NOTICE OF DECISION

CLASS 3 SITE PLAN REVIEW / CLASS 2 ADJUSTMENT / CLASS 2 DRIVEWAY APPROACH PERMIT / CLASS 1 DESIGN REVIEW CASE NO.: SPR-ADJ-DAP-DR24-27

SUMMARY: A proposal for a new 12-unit multi-family housing development.

LOCATION: 676 17th St SE, Salem OR 97301

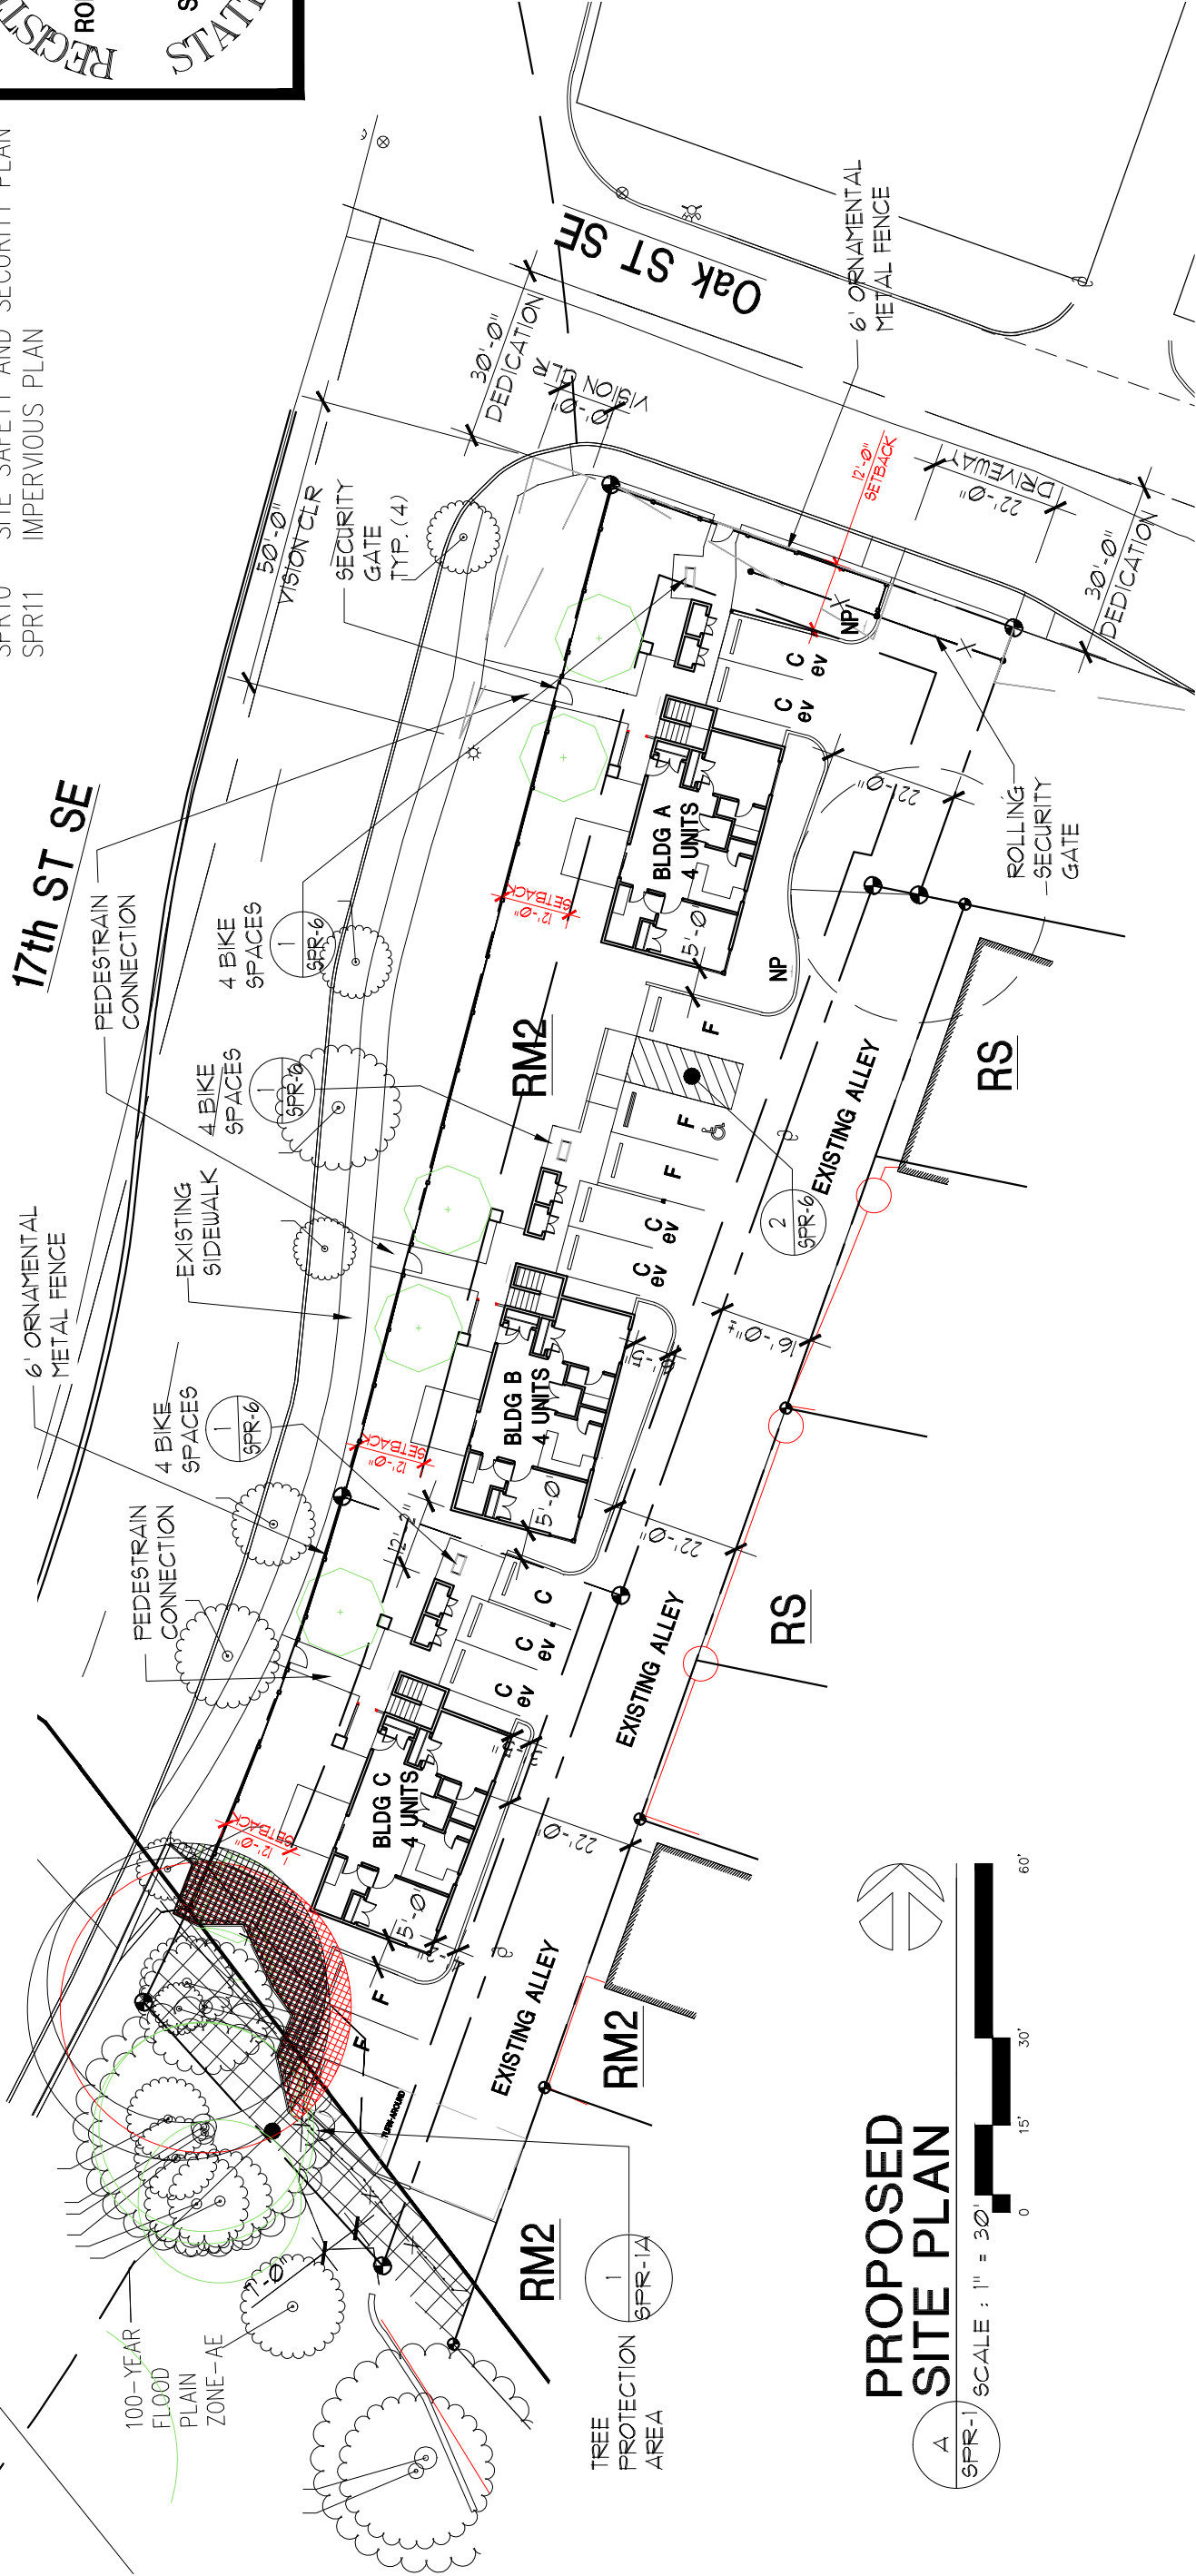
Finding: Vision clearance standards apply at the intersection of 17th Street SE and Oak Street SE (SRC 805.005(a)(2), as well as at the driveway approach onto Oak Street SE (SRC 805.005(b)(1)(B)). The applicant has incorrectly shown the required vision clearance area at the intersection of 17th Street SE and Oak Street SE. In addition, the development plans show a gate and fencing within the vision clearance area required for the driveway approach onto Oak Street SE. Per SRC 805.010, fencing and other obstructions are not permitted within the required vision clearance area. The applicants preliminary site plan does not comply with the vision clearance standards established in SRC Chapter 805. As a condition of approval, the applicant shall be required to provide an updated site plan that demonstrates compliance with vision clearance standards established in SRC Chapter 805. The following condition applies:

Finding: The development plans indicate a mix of compact and standard parking spaces at 90 degrees, served by a 24-foot-wide drive aisle coincident with the alley. The parking space located next to the screening wall of the Building A overhang is eight feet where a minimum eight and a half feet in width is required next to a support post or wall, per Table 806-5(5). To ensure the parking space will meet the dimensions, the following condition shall apply.

Finding: The proposed site plan indicates that 12 short-term bicycle parking spaces will be distributed throughout the development site in locations that are within 50 feet of primary building entrances. The racks, however, are not located where they are clearly visible from the building entrances. To ensure conformance with this standard, the following condition shall apply.

Finding: Vision clearance standards apply at the driveway approach onto Oak Street SE (SRC 805.005(b)(1)(B)). The applicant shows a gate and fencing within the vision clearance area required for the driveway approach onto Oak Street SE. Fencing and other obstructions are not permitted within the required vision clearance area (SRC 805.010). The applicant's preliminary site plan does not comply with the vision clearance standards established in SRC Chapter 805. As a condition of approval, the applicant shall be required to provide an updated site plan that demonstrates compliance with vision clearance standards established in SRC Chapter 805. To ensure compliance with the standards, the following condition shall apply.

Finding: The applicant's site plan shows a rolling gate at the driveway approach onto Oak Street SE. The gate is set back 12-feet from the property line, which does not provide

adequate space for a vehicle to wait for the gate to open without blocking vehicular traffic on Oak Street SE. The Assistant City Traffic Engineer has reviewed the site plan and found that the proposal, including the gate, would not provide for safe and efficient movement of vehicles in and out of the development site as it would interfere with vehicle movements within the street. The Assistant City Traffic Engineer requires the gate be moved 18-feet back from the curb along Oak Street SE, which will allow for one vehicle to queue and wait for the gate to open without blocking vehicle movements within the street. As shown in the Development Services Memo (**Attachment C**), the gate will be approximately 18-feet from the curb and align with the edge of the first parking space upon entering the site. With the following condition of approval, the driveway approach will ensure the driveway approach does not create a traffic hazard.

Finding: The development plans indicate a five-foot-wide “gravel or similar hard surface path” along the perimeter of the south end of Building C connecting the off-street parking spaces to the open space area. The proposed path does not extend and connect to each building. To ensure conformance with the standard, the following condition shall apply.

Condition 10: Prior to issuance of a building permit, the applicant shall submit a site plan that demonstrates compliance with Vision Clearance Standards established in SRC Chapter 805 for street and driveway intersections.

Condition 11: The applicant shall revise the plans to meet the minimum eight and a half-foot stall width where the side of the parking space abuts a wall or post.

Condition 12: The applicant shall revise the plans to relocate the bicycle parking spaces to be clearly visible from the primary building entrances, per SRC 806.060(a).

Condition 15: Prior to issuance of a building permit, the applicant shall submit a site plan that demonstrates compliance with Vision Clearance Standards established in SRC Chapter 805 for the driveway approach onto Oak Street SE.

Condition 16: The gate for the driveway approach onto Oak Street SE shall be setback approximately 18-feet from the back of the curb of Oak Street SE or the plans shall be revised to eliminate the gate.

Condition 17: The site plan shall be revised to include a pedestrian pathway that provides connection between each building, between each building and the common space area, and between each building and parking areas. The pedestrian pathway shall be a minimum of five feet wide and paved with a hard surface material.
